RESOLUTION AFFIRMING THE DECISION OF THE HISTORIC
PRESERVATION COMMISSION

CITY OF DES MOINES HISTORIC PRESERVATION COMMISSION
STAFF REPORT AND RECOMMENDATION
Wednesday, June 21, 2006

AGENDA ITEM #1

Part B) Construction of a carriage house.

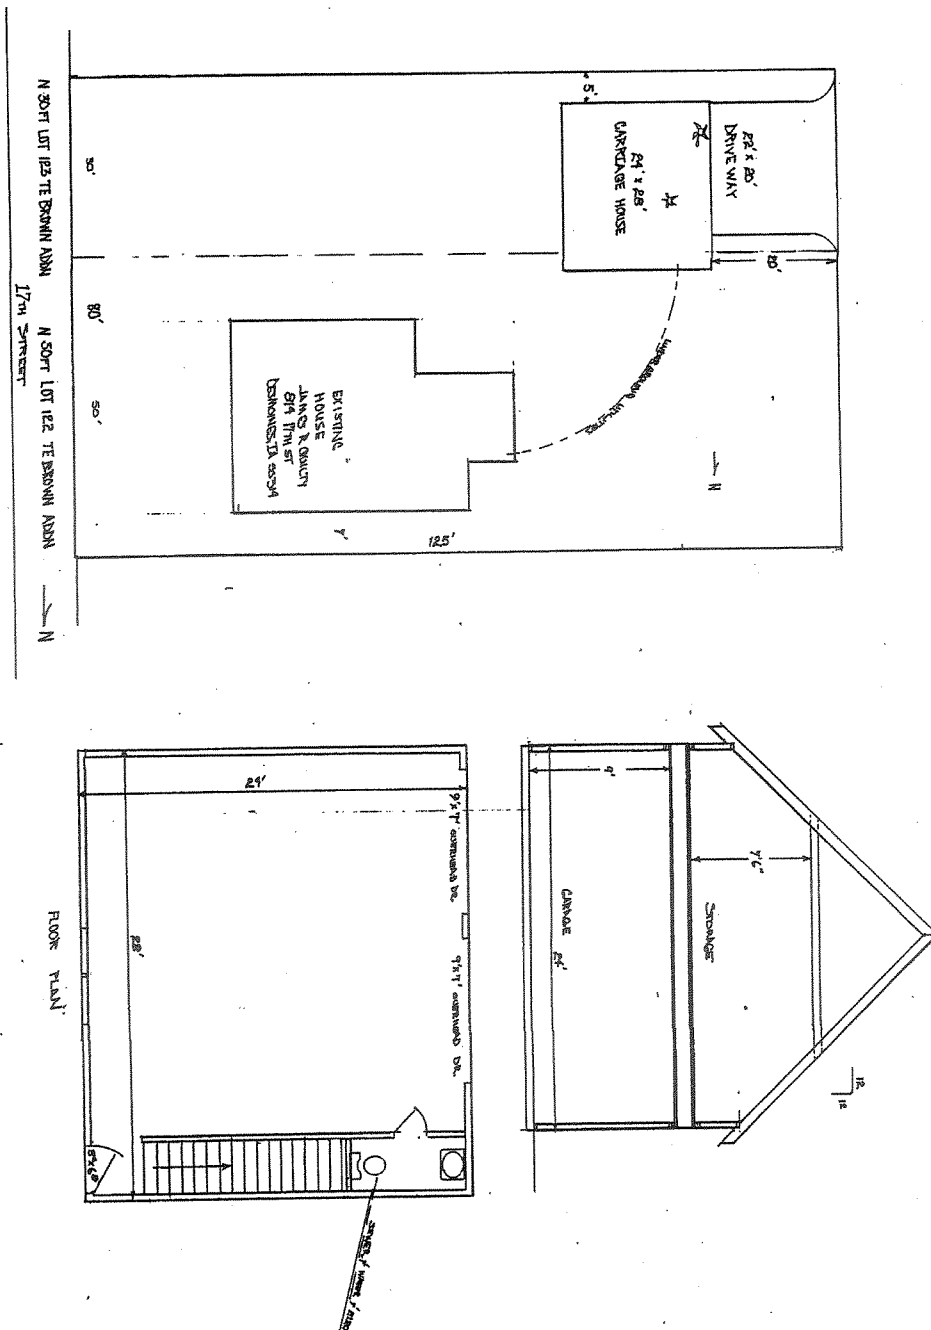
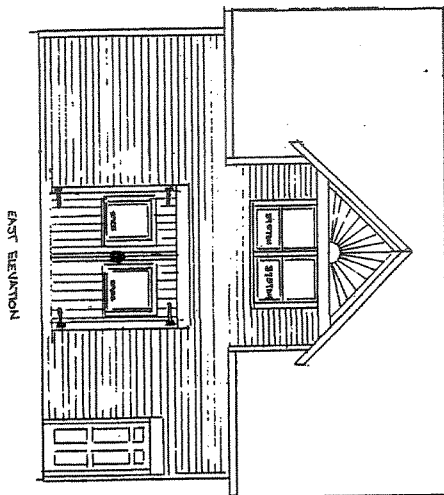
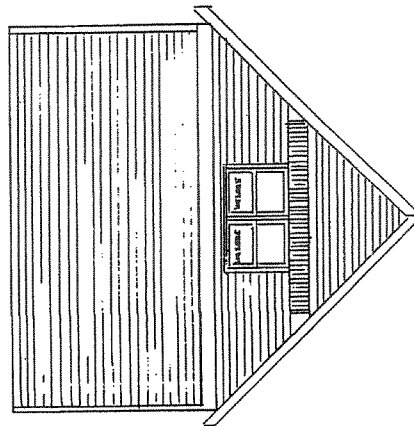
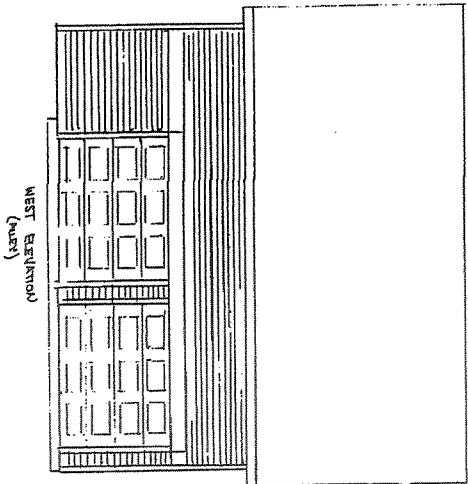
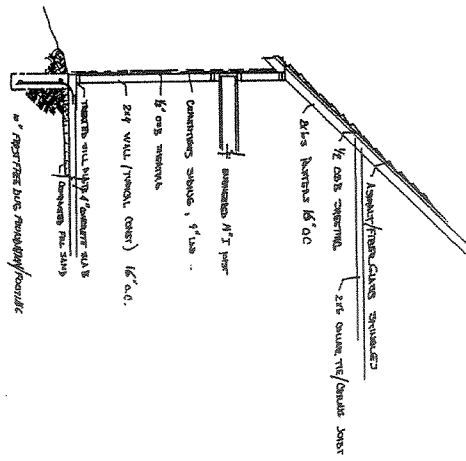
Staff believes that the placement of the carriage house as proposed interferes with the ability to meet the existing rhythm of building fronts on the 17th Street block face.

Staff also believes that the proposed carriage house could be shifted 10' closer to the 14' alley, which would still meet the minimum required 24' of maneuvering for the garage spaces. This would preserve rear yard space and be more in keeping with the character of the neighborhood.

Staff believes that the applicant is using a simple design in terms of scale, form, and material even with a small amount of ornamentation under the gables. While the actual interior floor height is 9', the exterior walls give the appearance of a 10' or 11' wall height to the eave.

The proposed carriage house would have a 12:12 roof pitch and narrow lap siding similar to the existing house.

The proposed carriage house includes paired double hung windows on the 2nd floor of the north, east, and south facades. The existing house primarily consists of elongated single double-hung windows with a set of paired windows on the front façade and on the south enclosed porch.

1. Shifting the location of the entire structure to a point three-feet north of the south property line of the applicant's current parcel and within 10' east of the west property line.
2. Compliance with the building code and obtainment of all necessary permits for construction.

- Carriage house to be built on 50'-wide parcel currently owned by the applicant (814 17th Street) 3' north of the south property and 10' east of the west property line.

1901 SANBORN MAPS

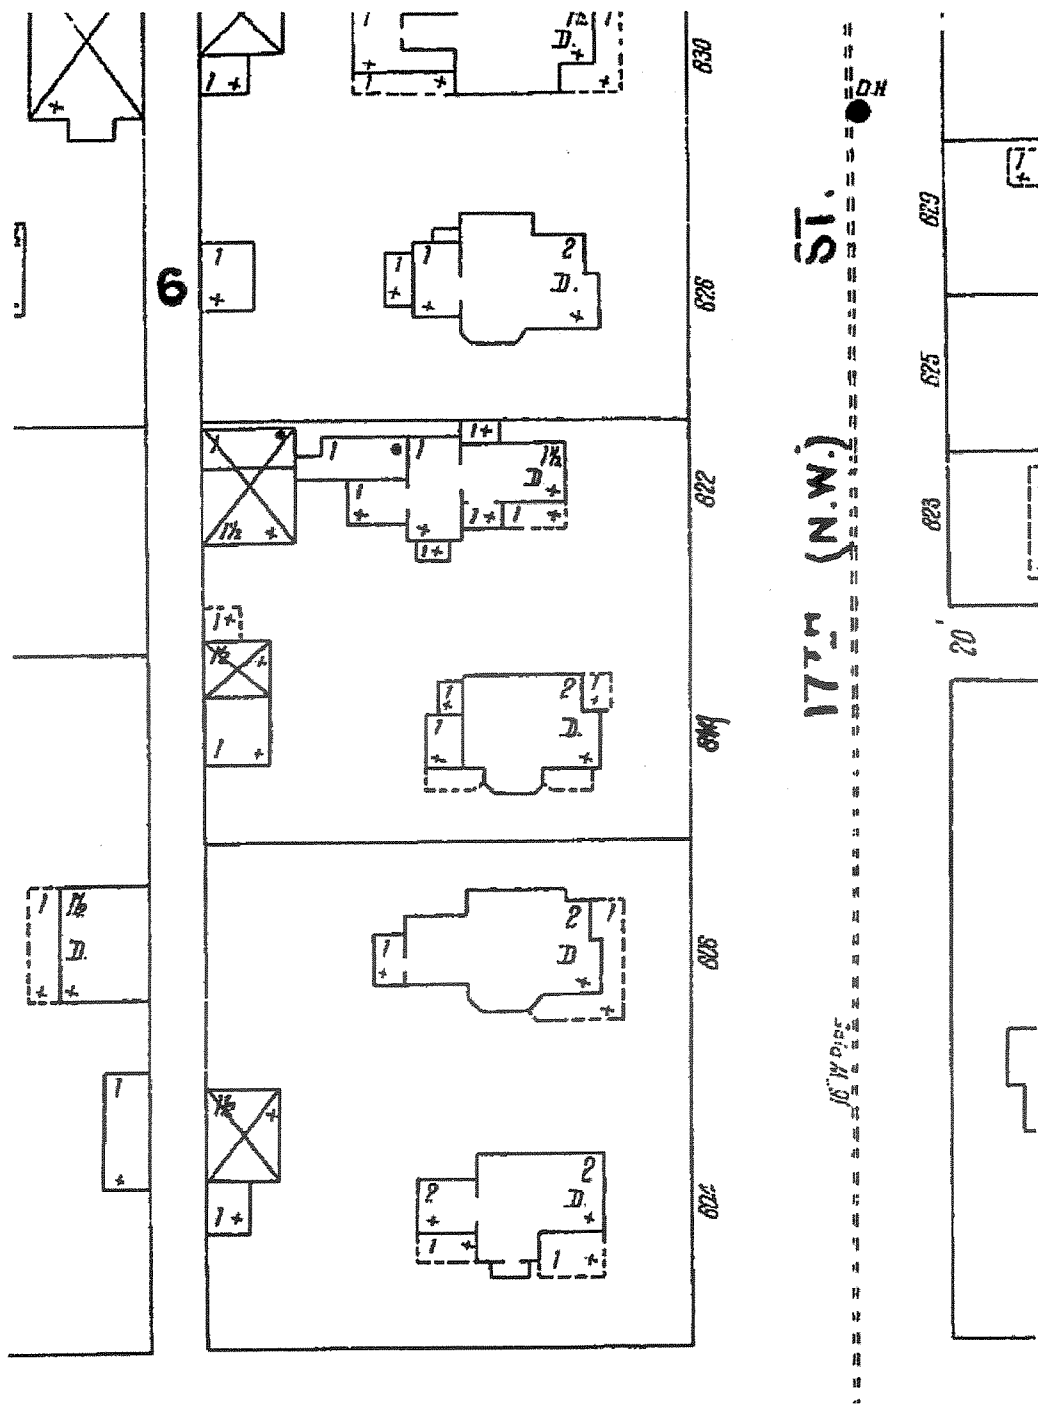
3. **Sanborn Map:** The 1901 map indicates that the subject property contained a single family dwelling with a 1-½ story accessory structure at the northwest corner of the parcel with an attached single-story portion on the south and a small attached open roof area on the north.

The historic locations of outbuildings were at both the northwest and southwest corners of the subject property according to the Sanborn maps. These guidelines suggest that the proposed outbuilding should be located further north within the confines of the original parcel for the subject property.

1920 SANBORN MAPS

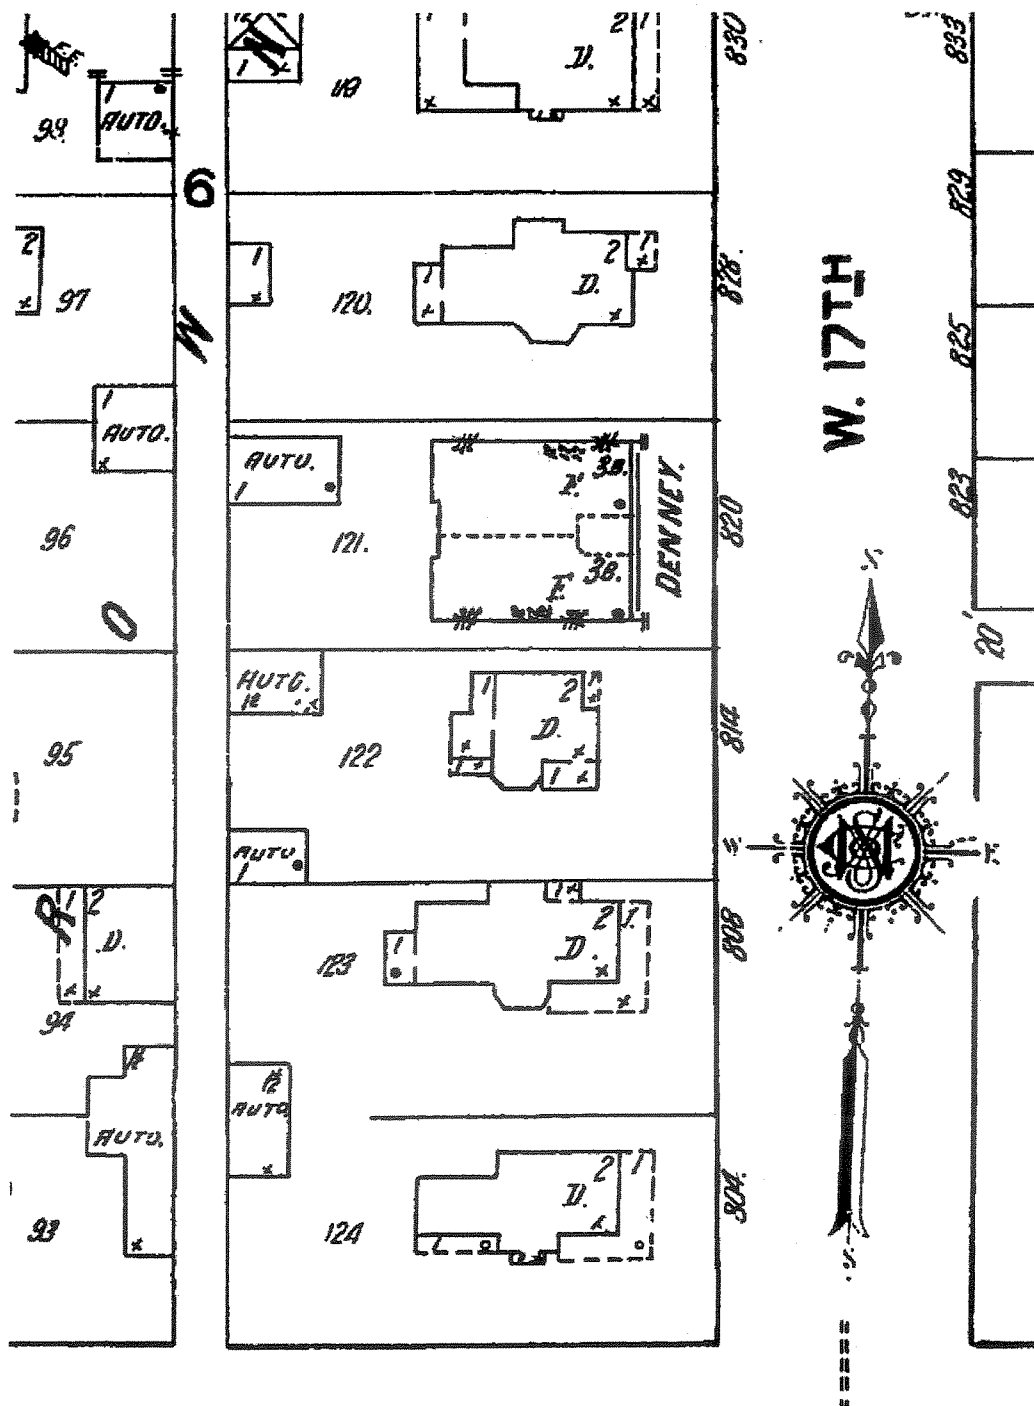
The 1920 map indicates the single-family dwelling in the same configuration and a 1-½ story garage in the same location but without the attachments indicated in 1901. The map indicated a second single-story garage at the southwest corner of the

1957 SANBORN MAPS

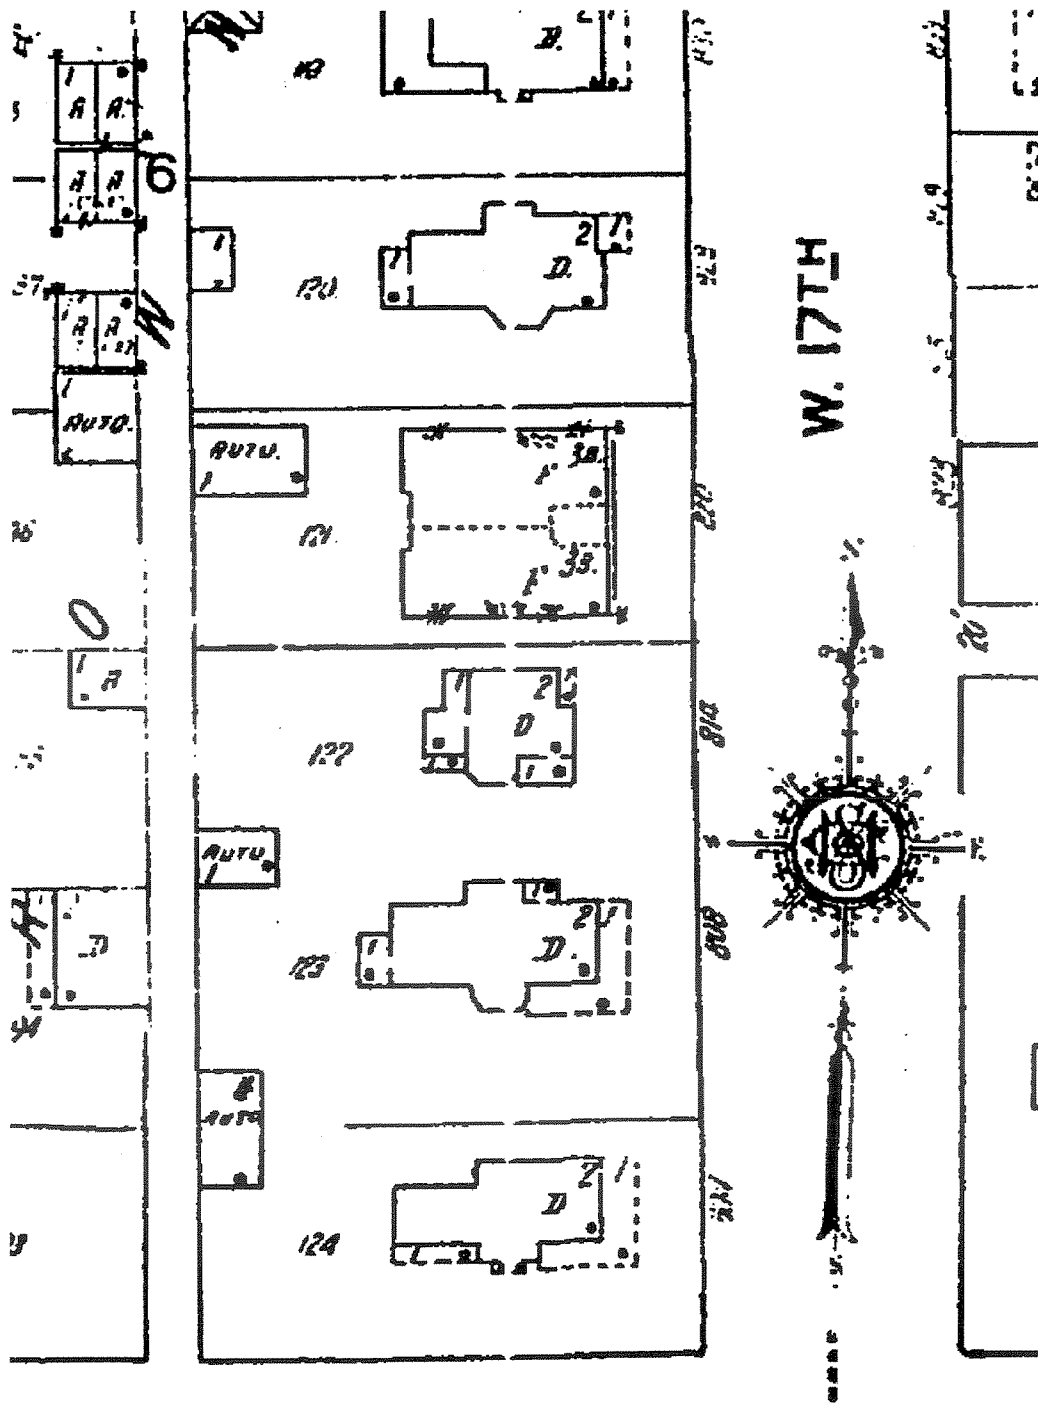
The 1957 map indicates the dwelling in the same configuration. However, the 1-½ story garage had been removed. A single-story garage at the southwest corner of the property still existed.
